WATERFORD - UNIT 3

9408160161 940811
PDR ADDOCK 05000382
PDR

1.9a The CORE OPERATING LIMITS REPORT is the Waterford 3 specific document that provides core operating limits for the current operating reload cycle. These cycle-specific core operating limits shall be determined for each reload cycle in accordance with Technical Specification 6.9.1.11. Plant operation within these operating limits is addressed in individual specifications.

FIGURE 3.2-1a

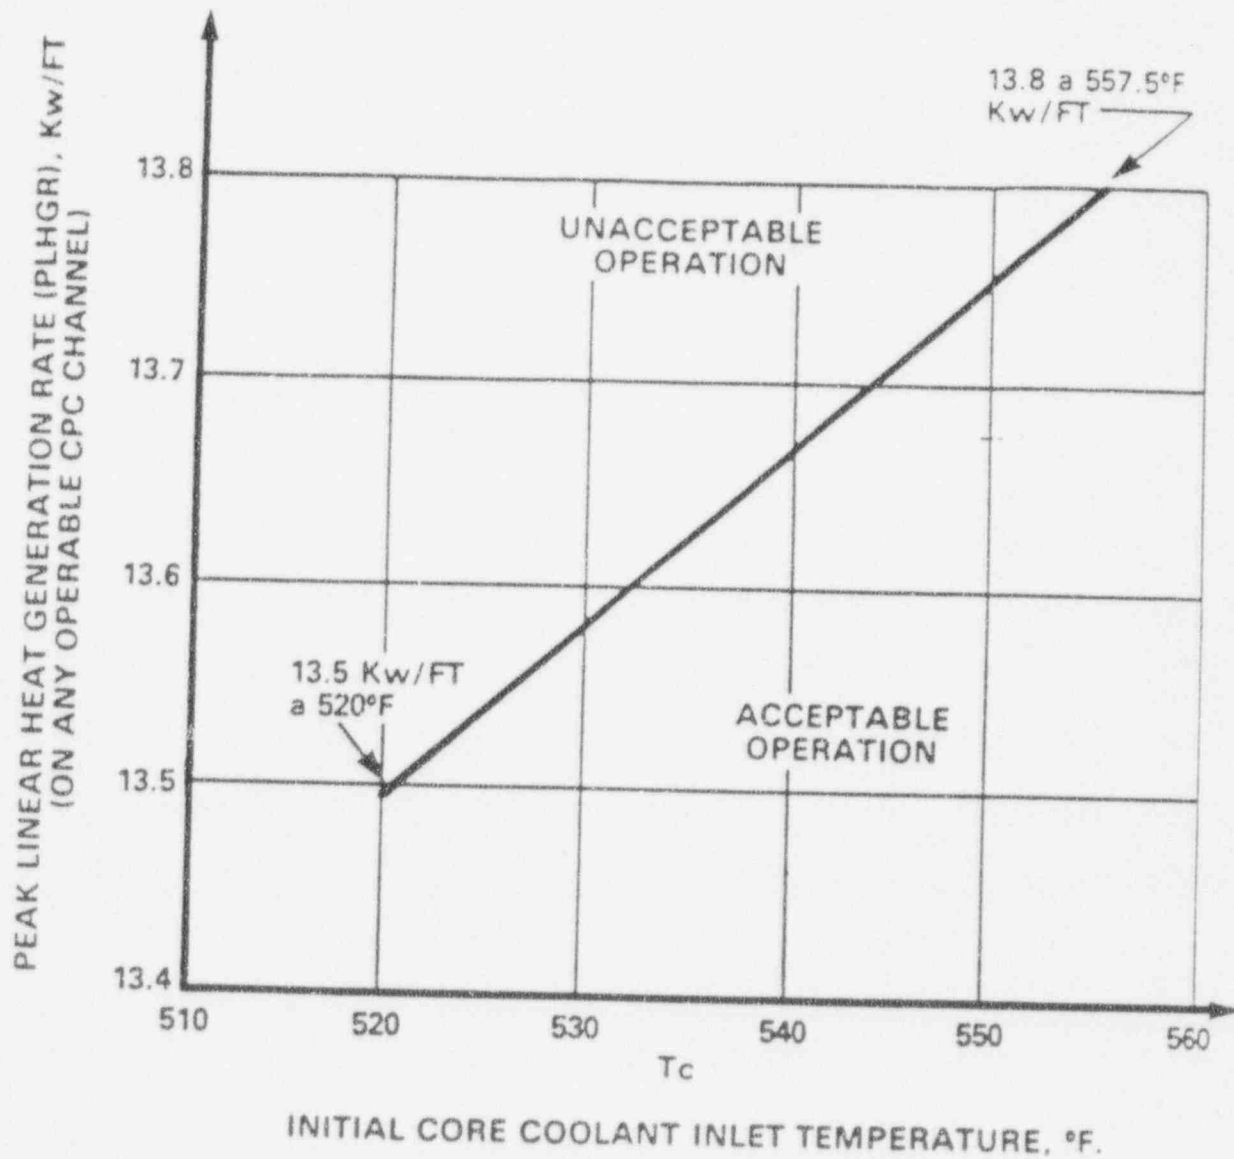
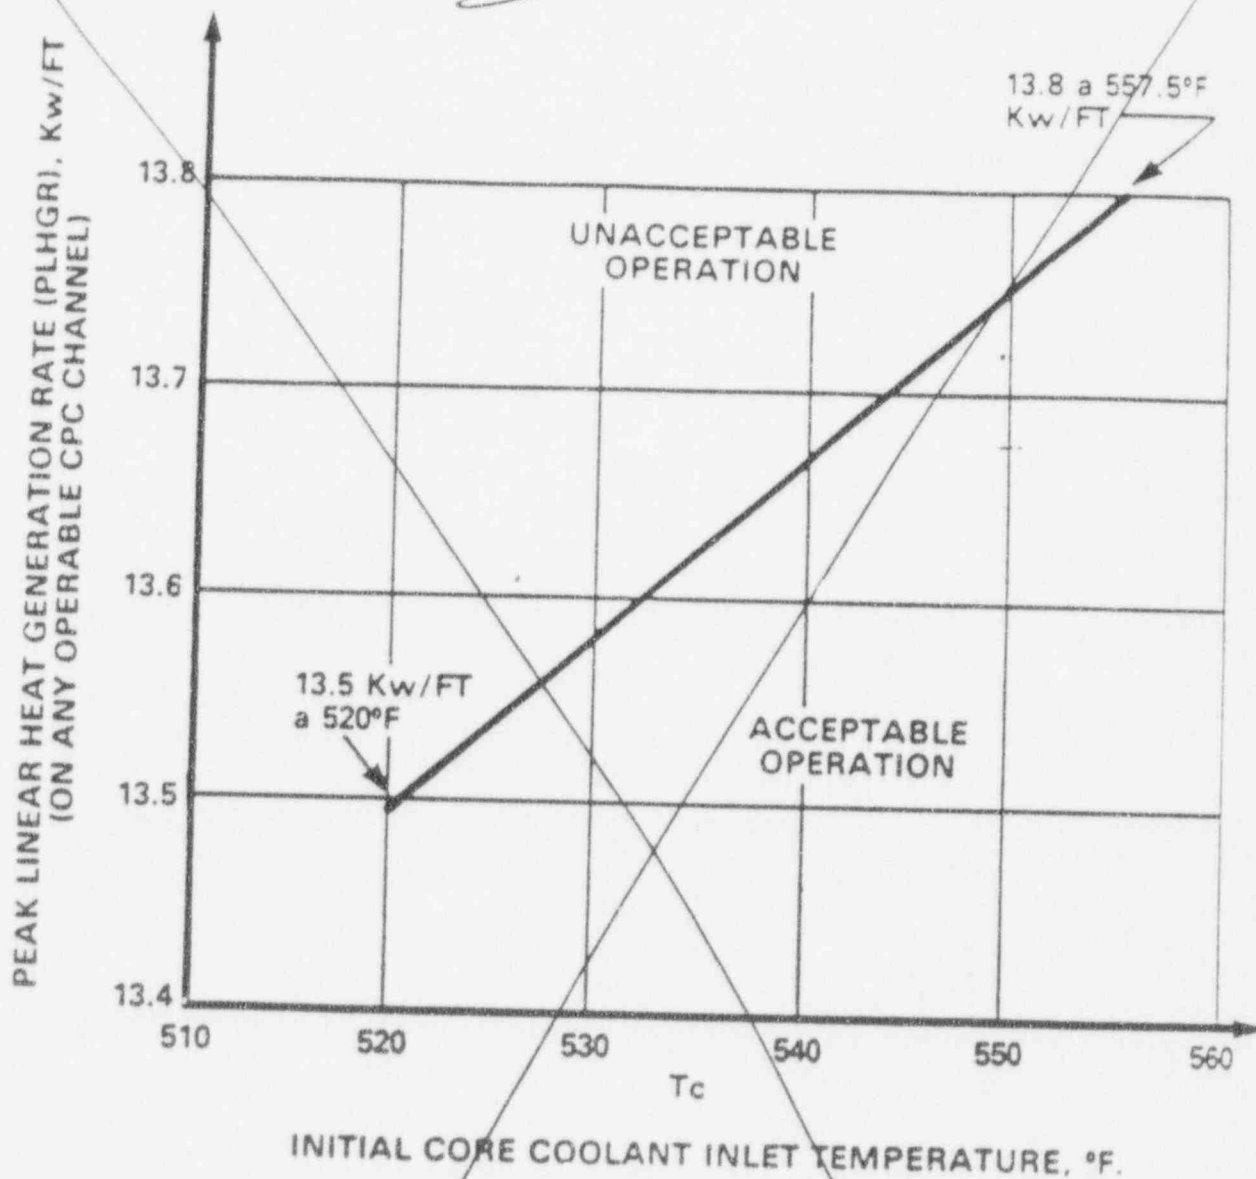
- a. Maintaining COLSS calculated core power less than or equal to COLSS calculated core power operating limit based on linear heat rate (when COLSS is in service); or
- b. Operating within the region of acceptable operation specified in the COLR ~~of Figure 3.2-1a~~ using any operable CPC channel (when COLSS is out of service).

- b. With the linear heat rate limit not being maintained as indicated by operation outside the region of acceptable operation specified in the COLR ~~in Figure 3.2-1a~~ with COLSS out of service, either:

(COLSS) or, with the COLSS out of service, by verifying at least once per 2 hours that the linear heat rate, as indicated on any OPERABLE Local Power Density channels, is within the limits specified in the COLR ~~shown on Figure 3-2-1a.~~

The additional uncertainty terms included in the CPC's for transient protection are credited in the limits specified in the COLR Figure 3-2-1a since this curve is intended to monitor the LCO only during steady state operation.

FIGURE 3.2-2

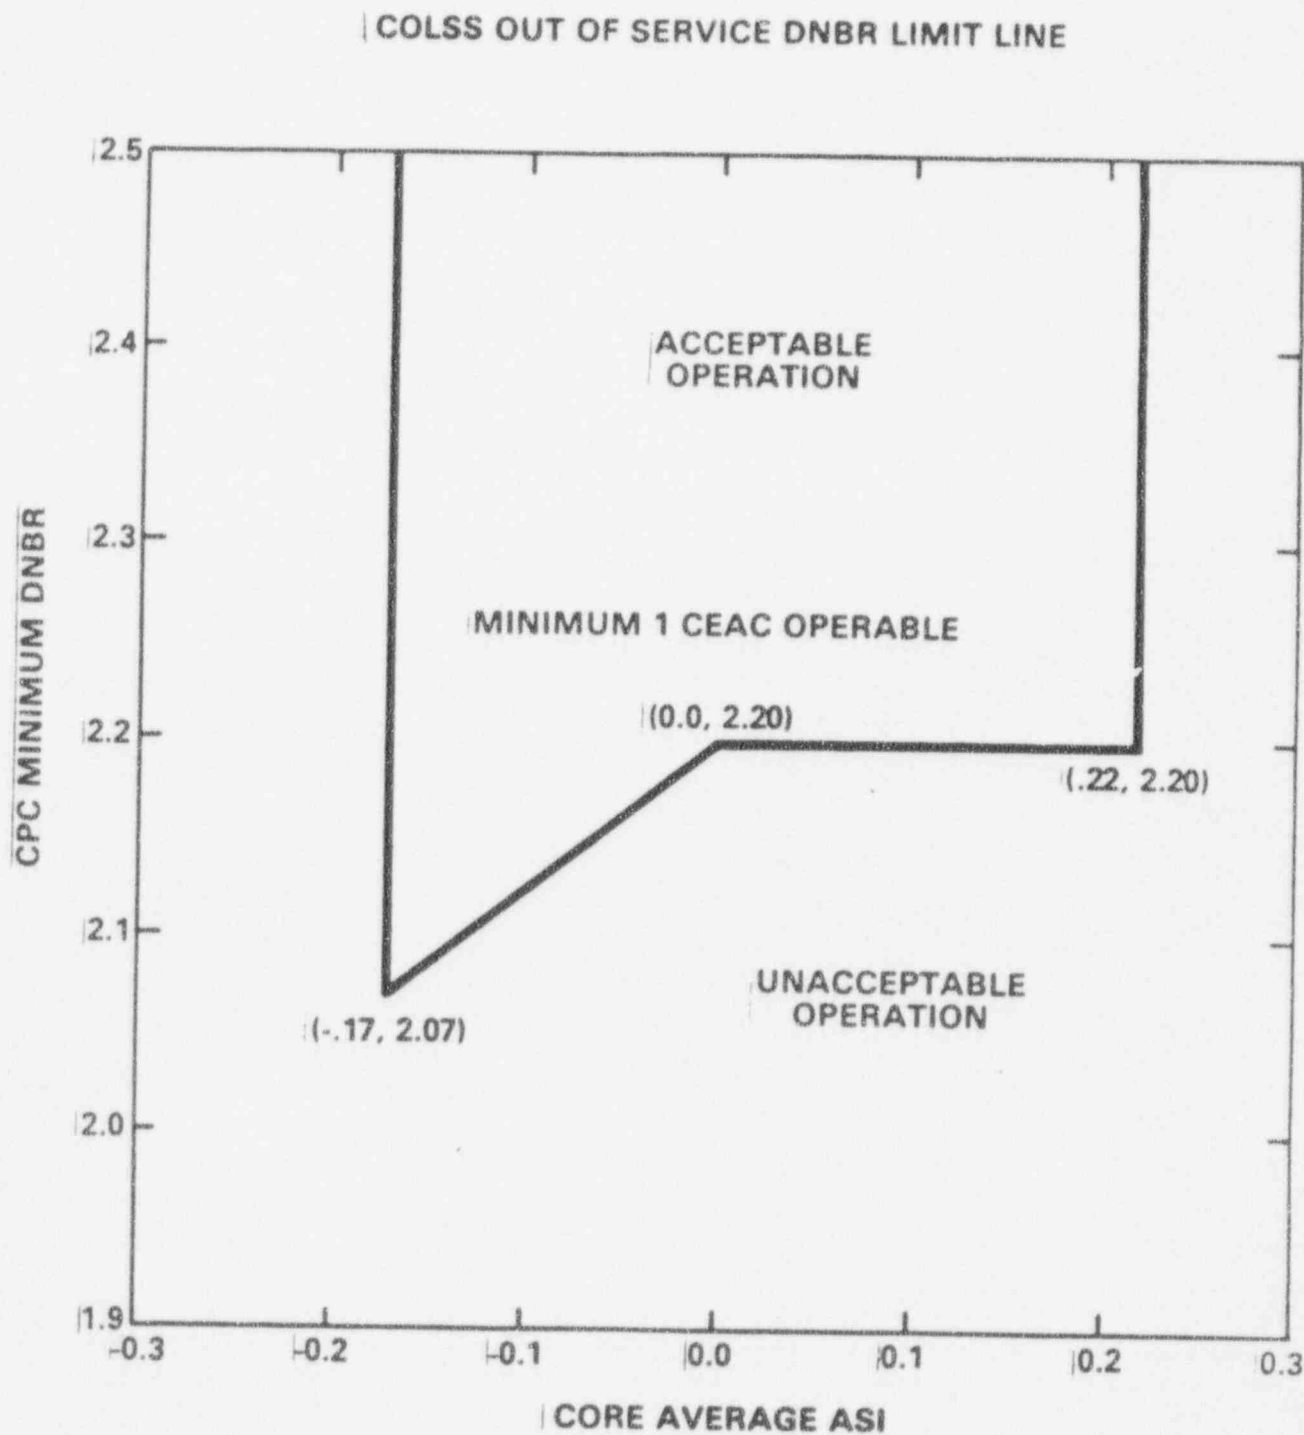
4.2.4.2 The DNBR shall be determined to be within its limits when THERMAL POWER is above 20% of RATED THERMAL POWER by continuously monitoring the core power distribution with the Core Operating Limit Supervisory System (COLSS) or, with the COLSS out of service, by verifying at least once per 2 hours that the DNBR, as indicated on any OPERABLE DNBR channel, is within the limit specified in the COLR ~~shown on Figure 3.2-2 or Figure 3.2-3.~~ |

DELETE

Pages 3/4 2-7
Through
Page 3/4 2-9
Are Not used

FIGURE 3.2-3

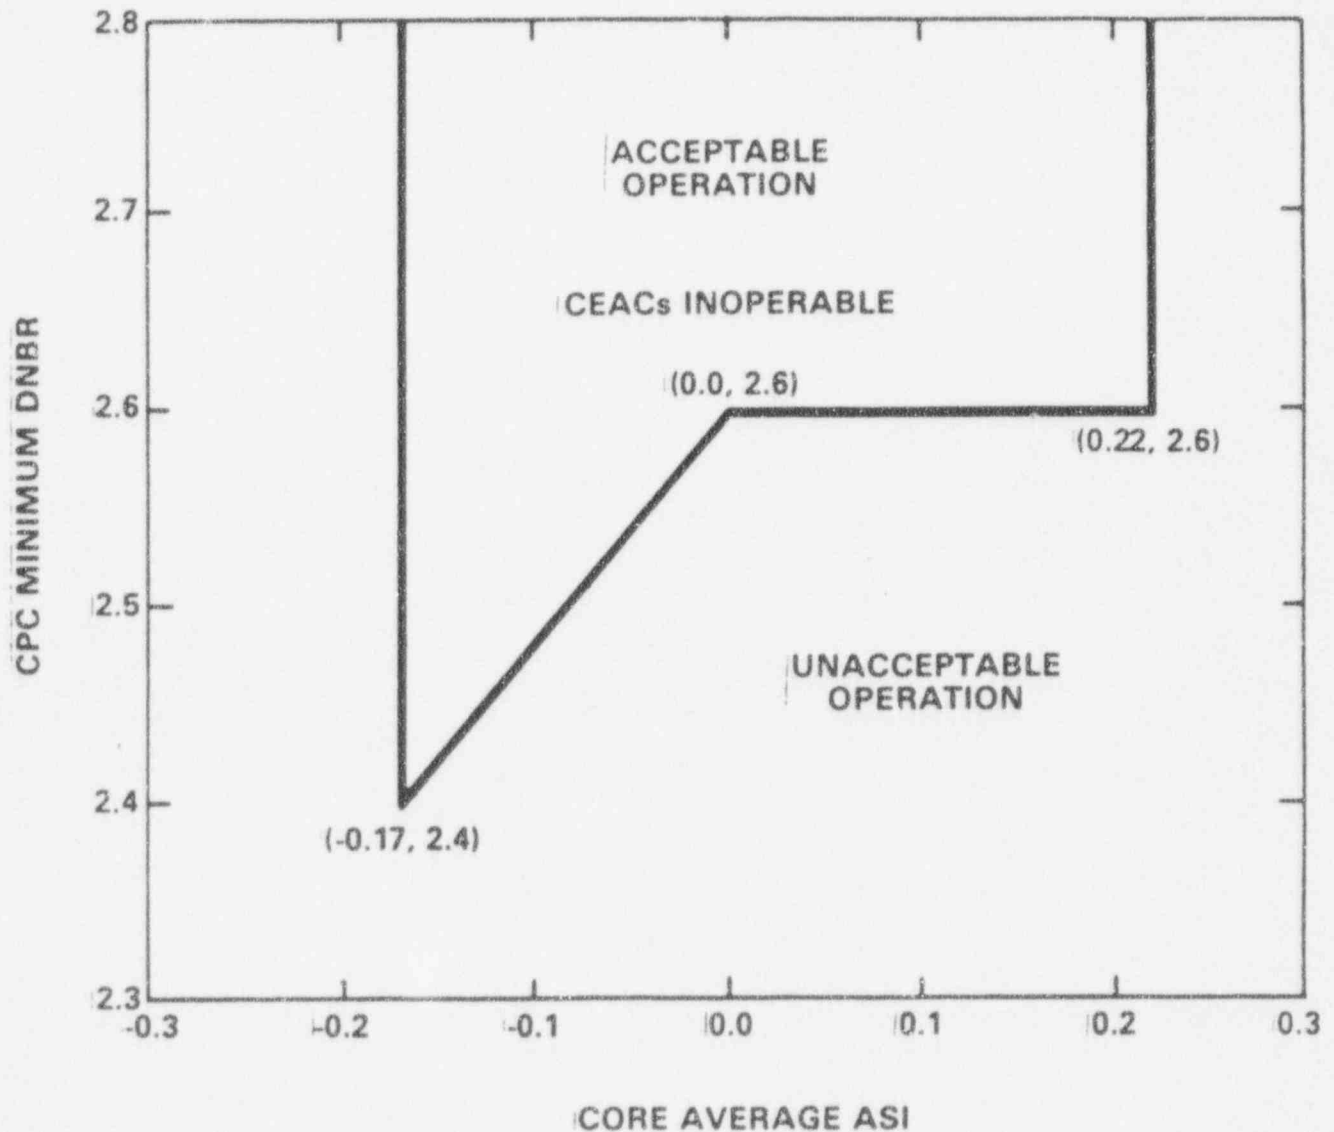
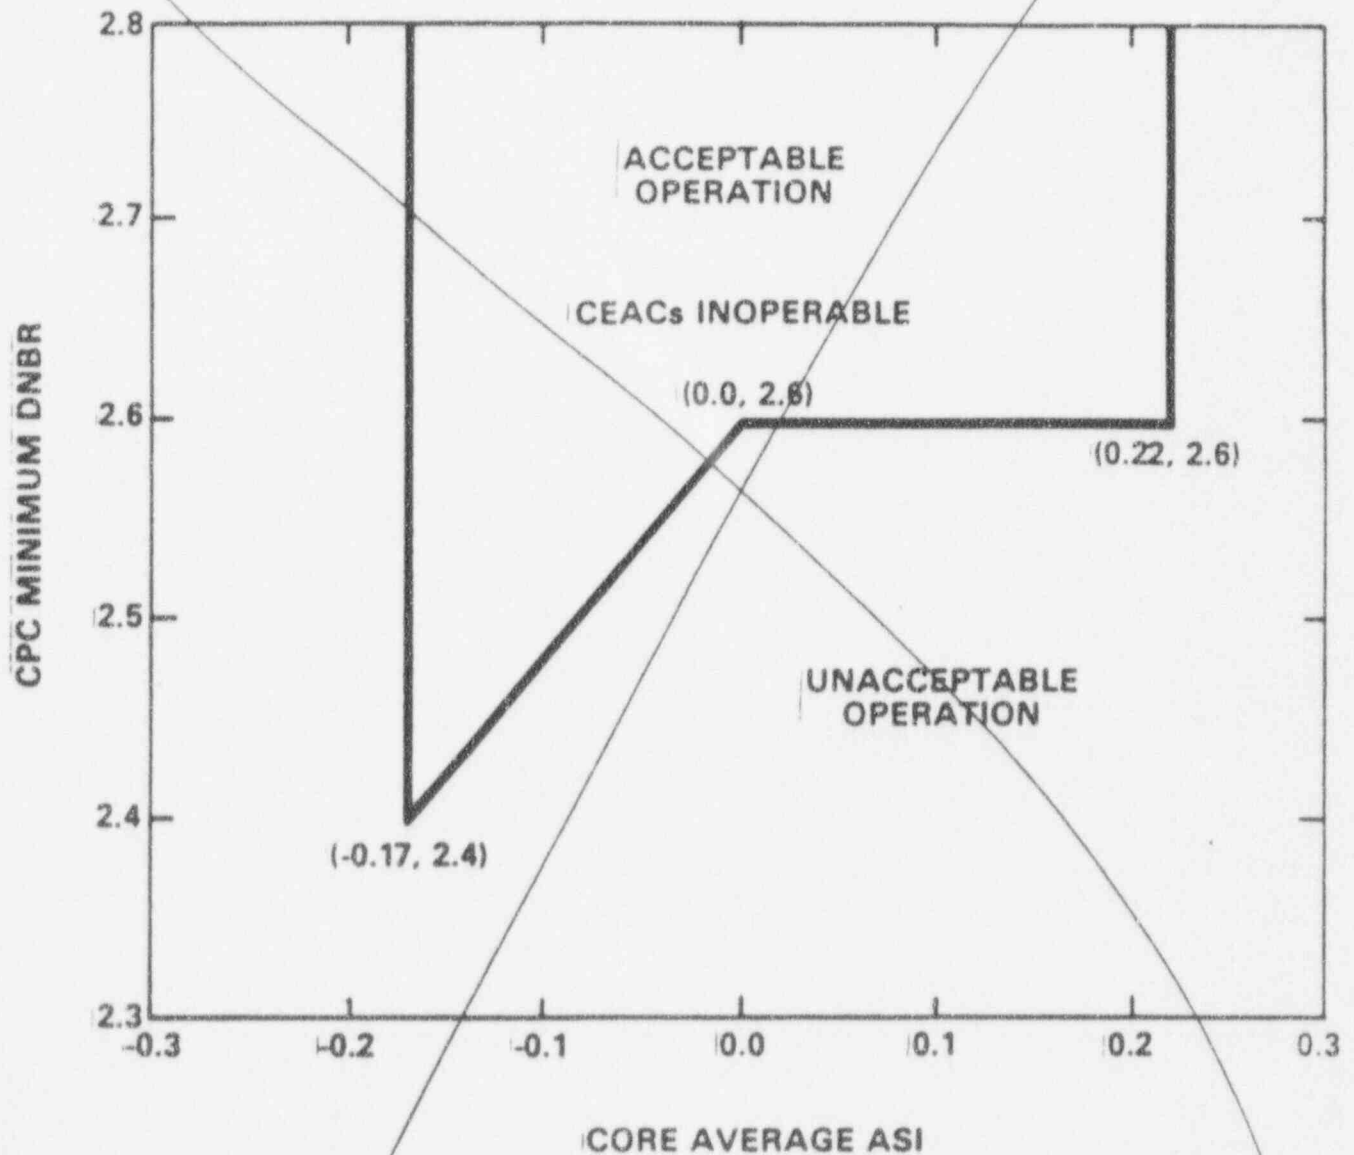
Parameters required to maintain the margin to DNB and total core power are also monitored by the CPCs. Therefore, in the event that the COLSS is not being used, operation within the limits specified in the COLR of Figure 3.2.2 or Figure 3.2.3 can be maintained by utilizing a predetermined DNBR as a function of AXIAL SHAPE INDEX and by monitoring the CPC trip channels. The above listed uncertainty and penalty factors plus those associated with startup test acceptance criteria are also included in the CPCs which assume a minimum core power of 20% of RATED THERMAL POWER. The 20% RATED THERMAL POWER threshold is due to the neutron flux detector system being inaccurate below 20% core power. Core noise level at low power is too large to obtain usable detector readings.

FIGURE 3.1-3 PART LENGTH CEA INSERTION LIMIT VS. THERMAL POWER

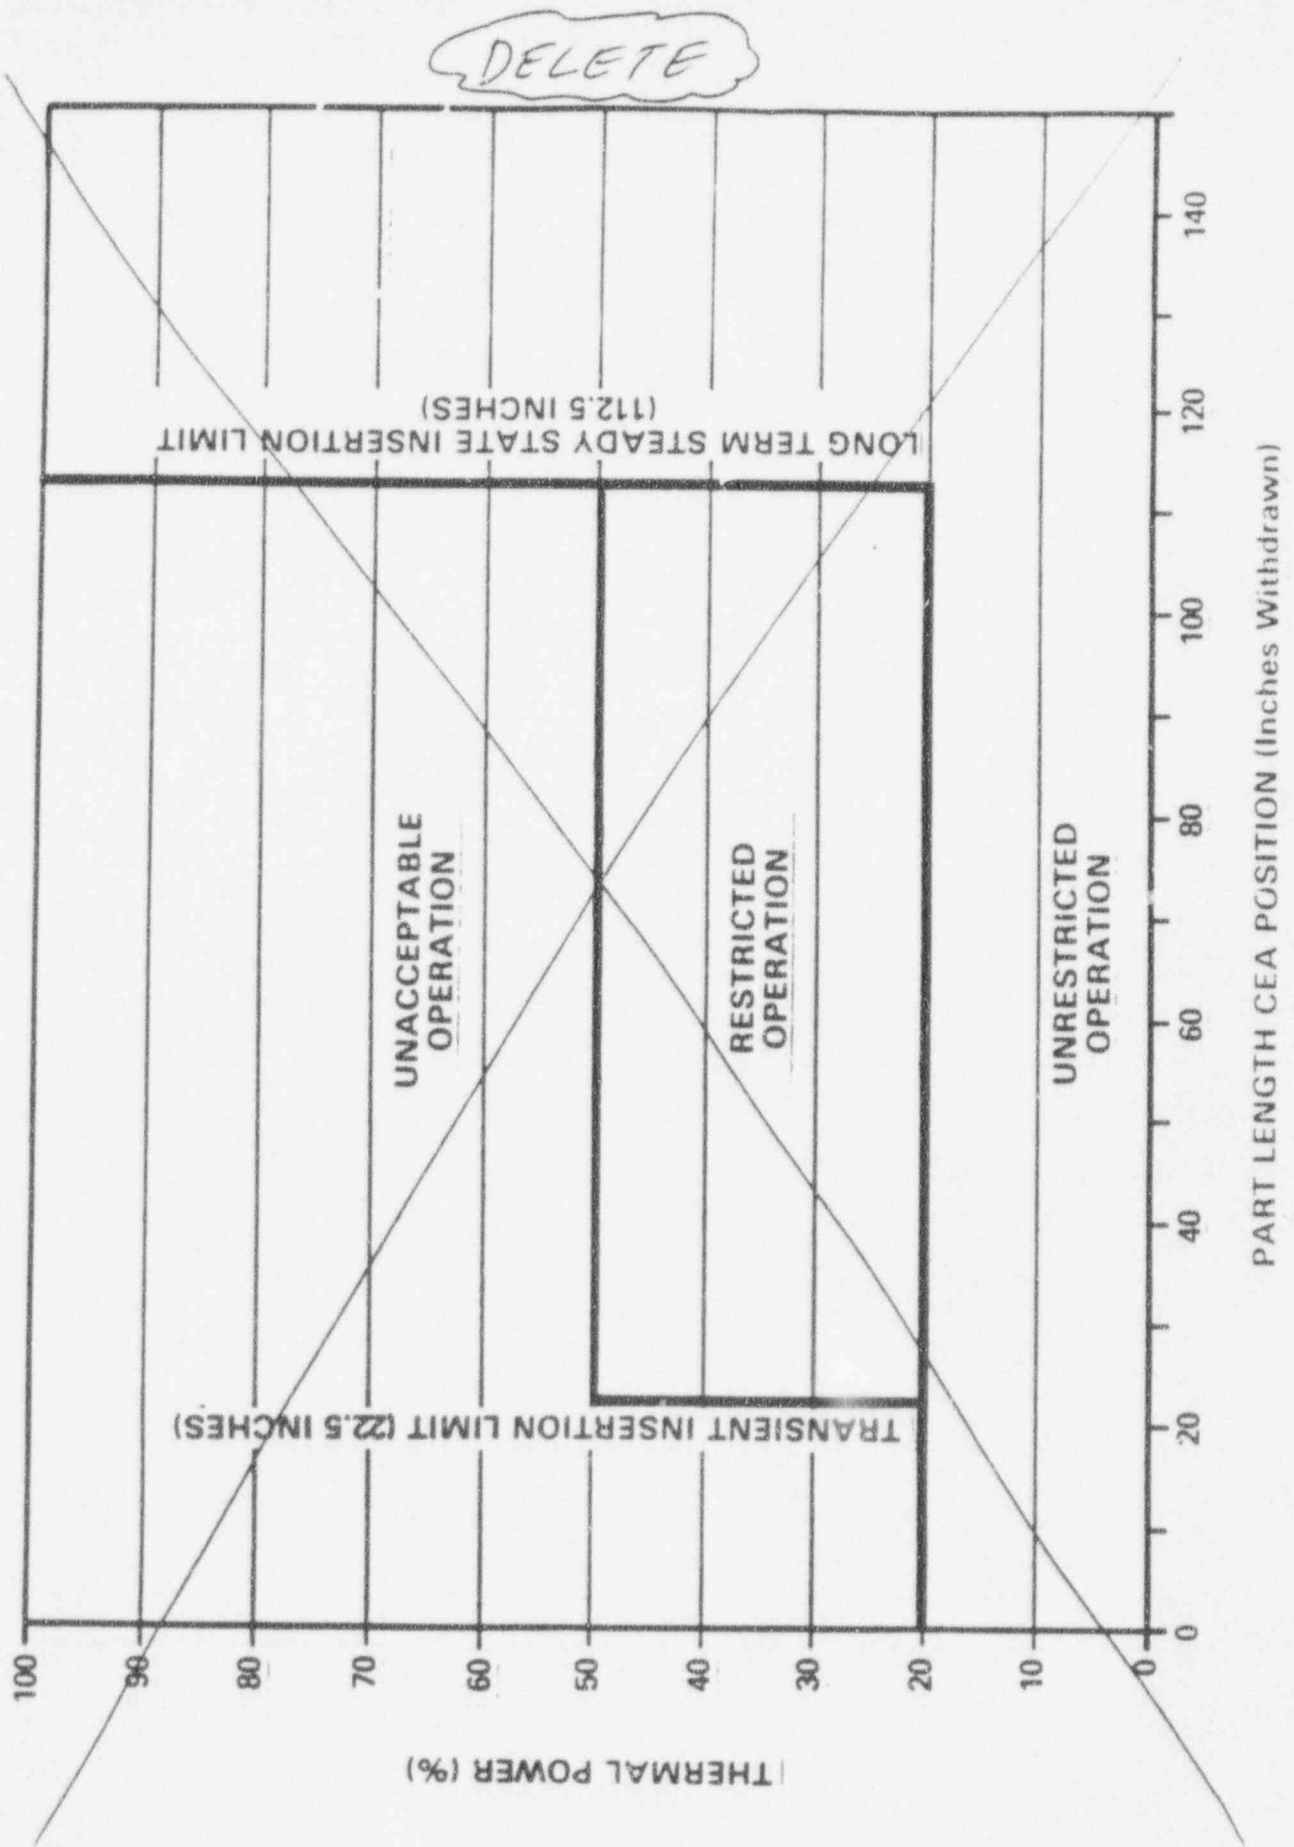
3.1.3.7 The part length CEA groups shall be limited to the insertion limits specified in the COLR ~~shown on Figure 3.1-3~~ with PLCEA insertion between the Long Term Steady State Insertion Limit and the Transient Insertion Limit restricted to:
